APPLICATION NO.	FILING DATE	FIRST NAMED INVENTOR	ATTORNEY DOCKET NO.	CONFIRMATION NO.
29/867,397	10/24/2022	Andreas Papenfuss	BMLP.D020 20/4025695	8428
69842	7590	06/24/2025		
Oppedahl Patent Law Firm LLC -- BMLP			EXAMINER	
P O Box 351240			DAVID, ALEXANDER JOSEPH	
Westminster, CO 80035				
			ART UNIT	PAPER NUMBER
			2938	
			NOTIFICATION DATE	DELIVERY MODE
			06/24/2025	ELECTRONIC

Creative tool

Examiner's Comment

Fig. 12

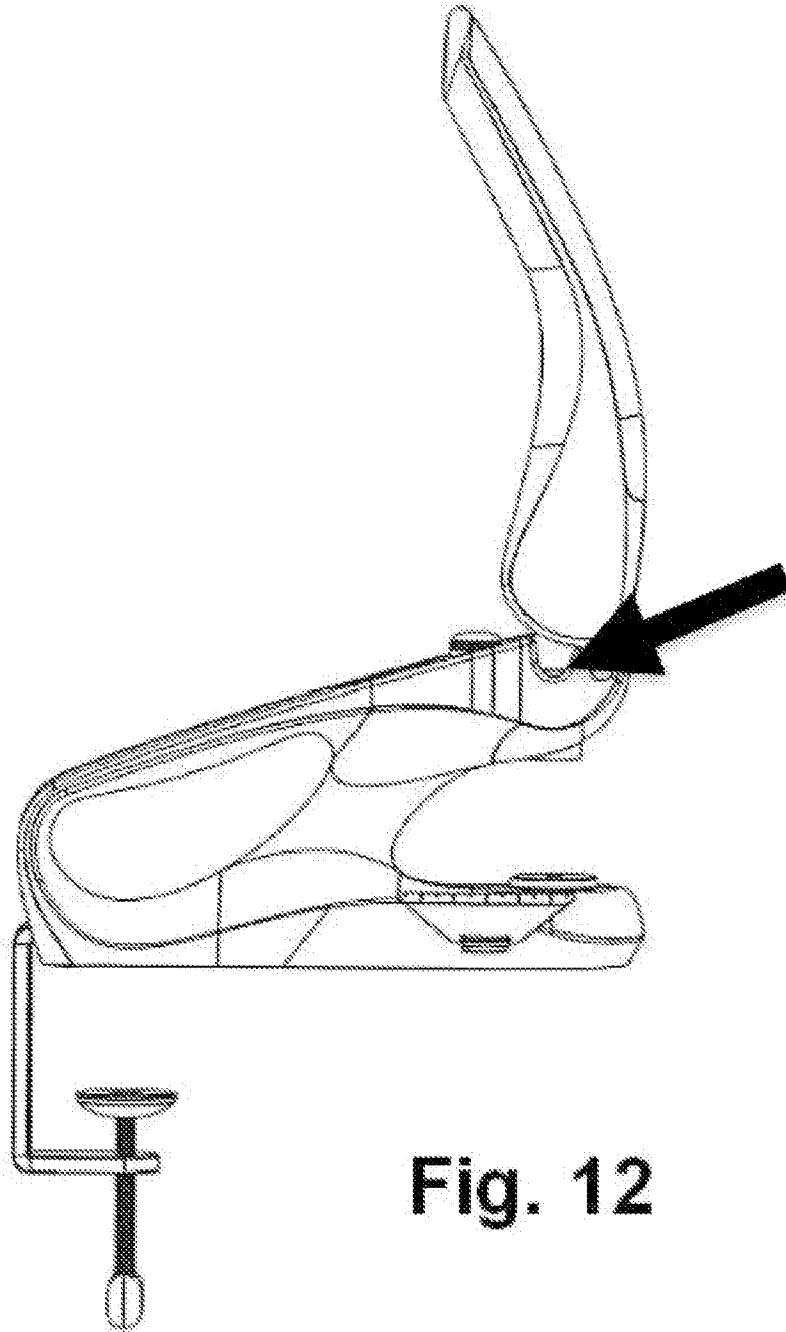
- In Figures 10 and 12 (Figure 12 shown), the area within the recess, annotated with an arrow, is indefinite and non-enabled as it's precise location cannot be determined.

Fig. 13

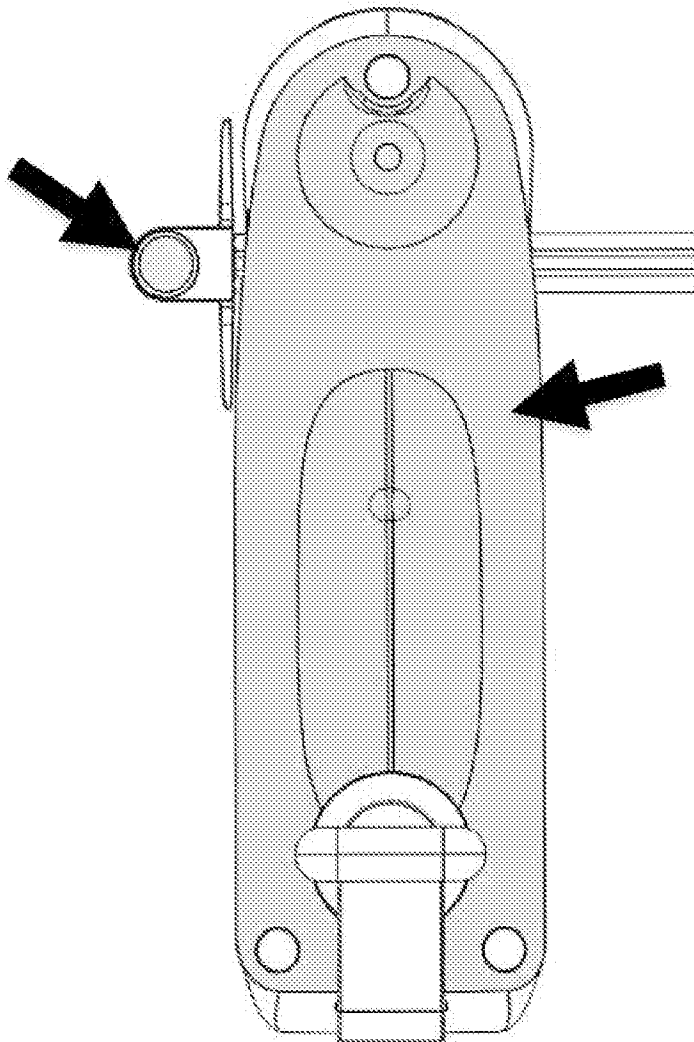
- In Figure 12, shown below, the highlighted areas are indefinite and non-enabled as their shape and location cannot be determined from a single view.
